1980 Corvette: Service Bulletin: Rear Wheel Spindle Yoke Snapping Noise

Model and Year: 1980 Corvette

Bulletin No: 80-T-44

Date: June, 1980

FIGURE 1

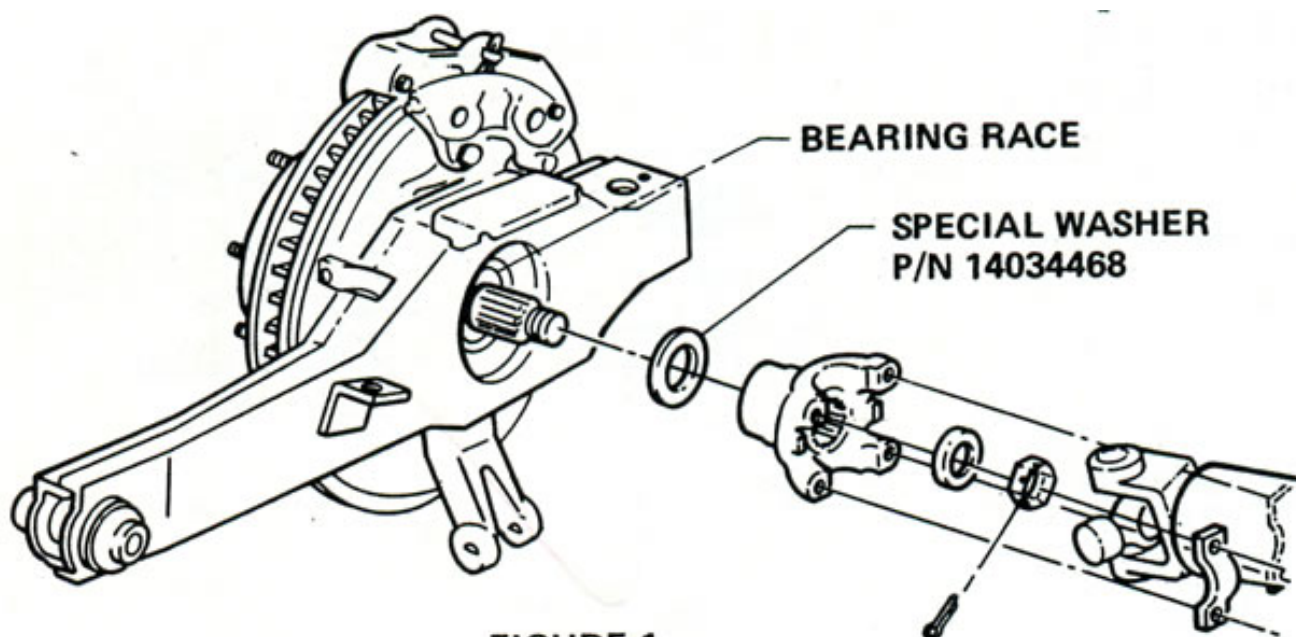
Owners of 1980 Corvettes, primarily those equipped with a manual transmission, may experience a snapping or crunching noise from either or both rear wheel locations during torque reversals and during acceleration or deceleration. This noise is the result of scuffing of the rear wheel spindle yoke against the inner wheel bearing inner race.

This condition can be corrected by installing a special Moly coated washer (P/N 14034468) between the spindle yoke and the inner wheel bearing (see Figure 1). Steps 2 through 8 of the following Service Procedure should be performed at each rear wheel.
